UNITED STATES COURT OF APPEALS
FOR THE DISTRICT OF COLUMBIA CIRCUIT

SHIELDALLOY METALLURGICAL CORPORATION

SUPPLEMENTAL APPENDIX

6. Letter from NRC to Shieldalloy Re: Transmittal of Requests for Additional Information Involving Engineered Barrier Design, Mixed Waste and ALARA Issues at Shieldalloy's Newfield, NJ Facility (2/17/2009)	81

Figure 18.8 - Engineered Barrier Construction Detail

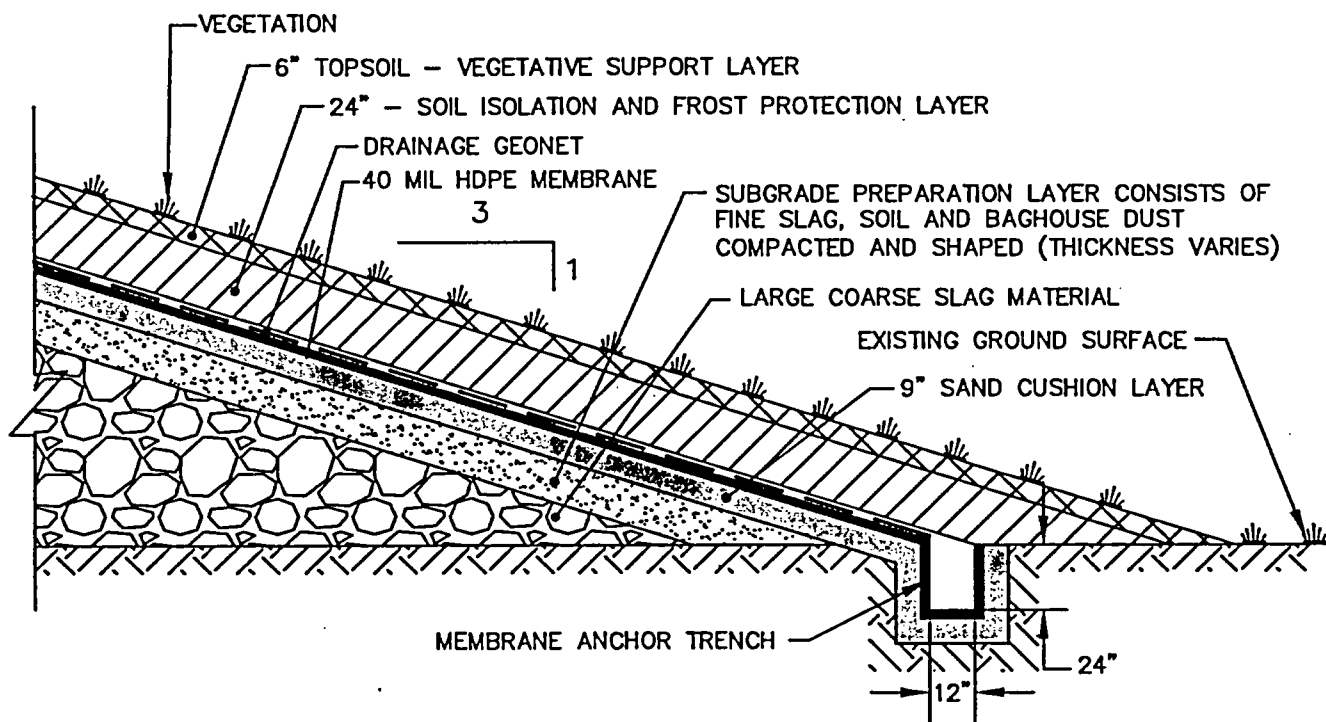
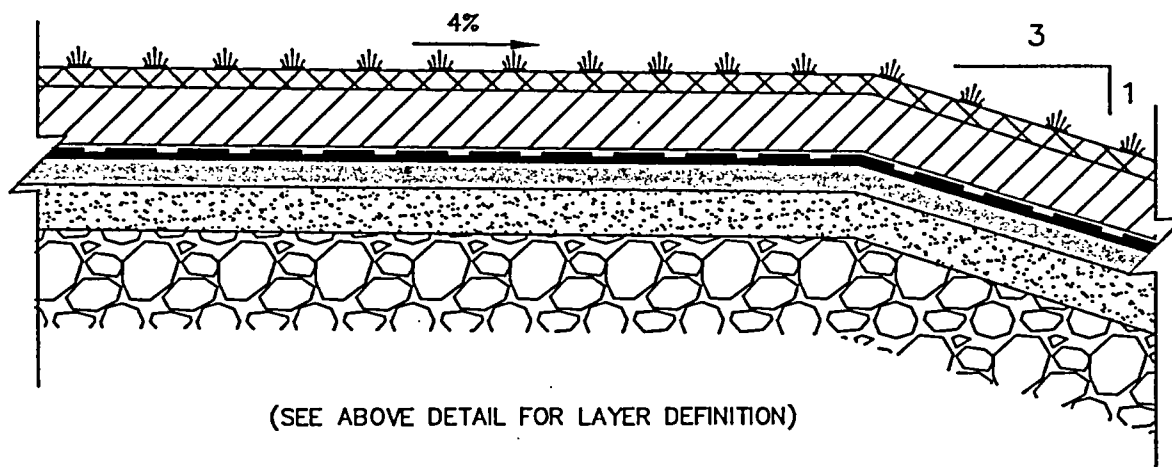
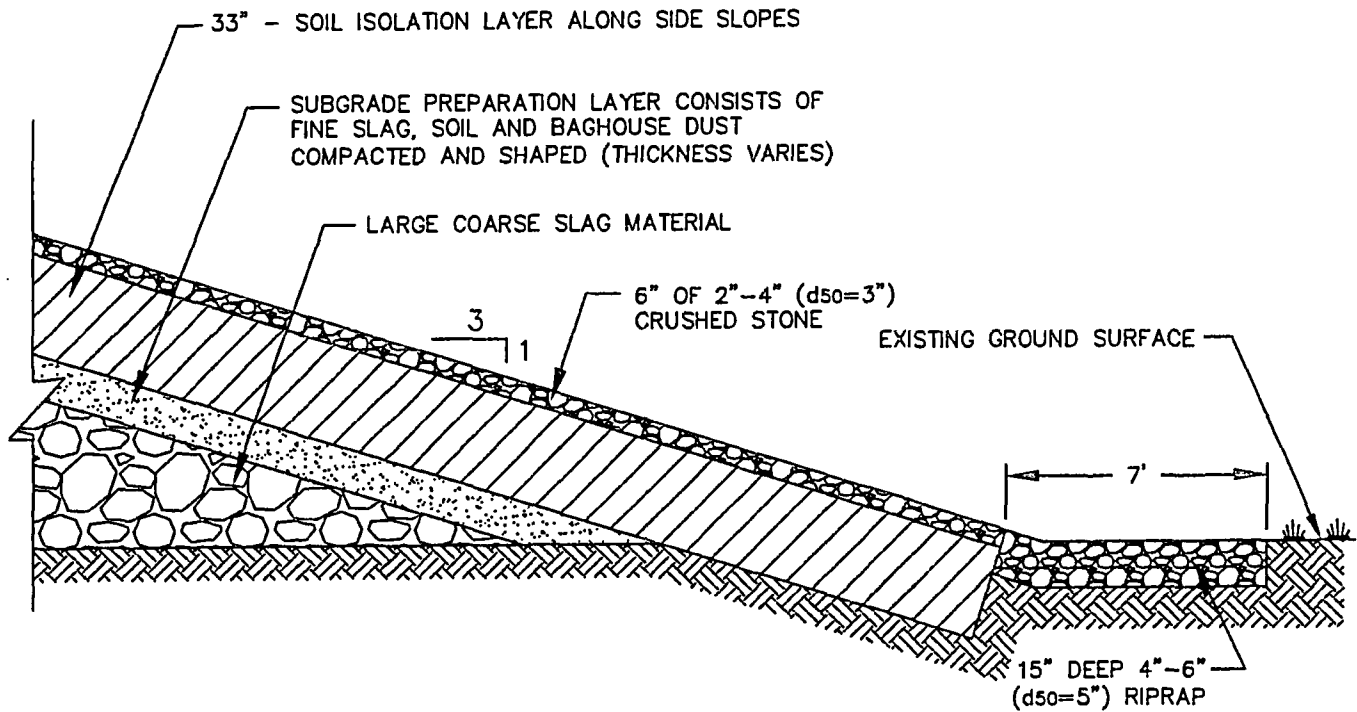
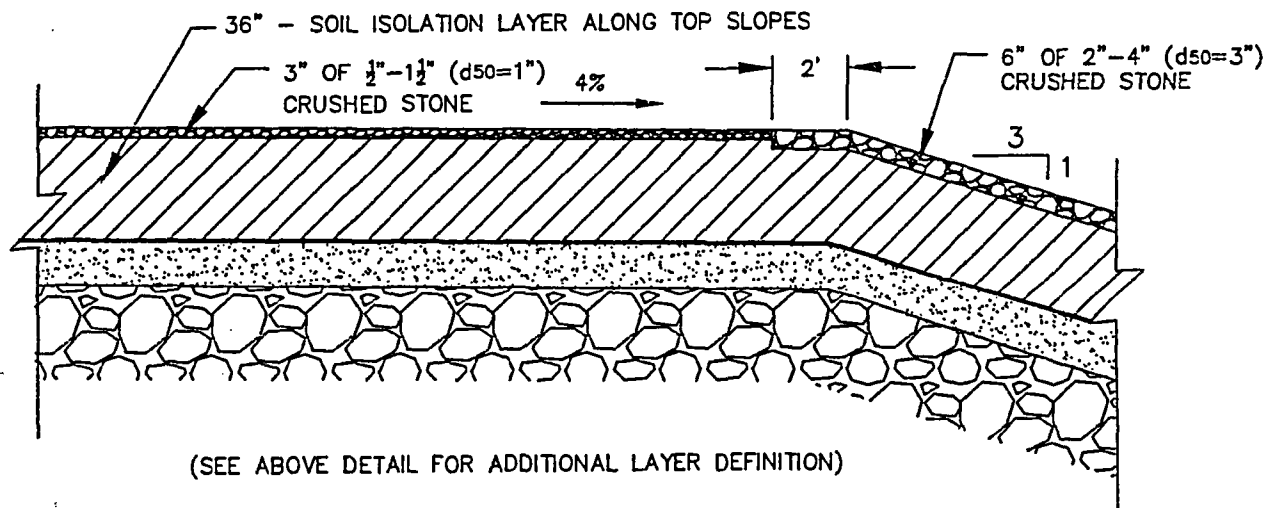
Action to be Taken: See action to be taken with respect to Issue No. 7. The need for rock to be placed on the side slopes has been evaluated within the new analyses and more conservative design factors have been incorporated. Rock has been incorporated into the new engineered barrier design and separate evaluations are presented for the top slope, the side slope and the toe of the side slopes. See the Appendices referenced in the response to Issue No. 7 above for the revised evaluations.

USNRC Issue No. 13: Major areas with either missing or insufficient information include: (4) Demonstration that the engineered cap has been designed to be sufficiently robust to remain effective even assuming loss of monitoring and maintenance (interim guidance, p. 11) (see also comment above on erosion control).

Figures 18.6, 18.7, 18.8 and 18.9 also required revision to reflect the new engineered barrier design. Appendix G of this document contains the revised figures. Figures 18.6 through 18.9 that currently exist in all USNRC copies of the DP should be removed and replaced with the figures in Appendix G in order to upgrade them to Rev. 1a.

Action to be Taken: See actions to be taken with respect to Issues No. 7 and 8. With the incorporation of a new engineered barrier design that includes the placement of rock on the top and side slopes as well as the toe of the side slopes, the accompanying engineering evaluations conducted in accordance with NUREG-1623 guidance demonstrate the protectiveness of these features, even without continued monitoring and maintenance. These revised evaluations clearly demonstrate the robustness of the engineered barrier.
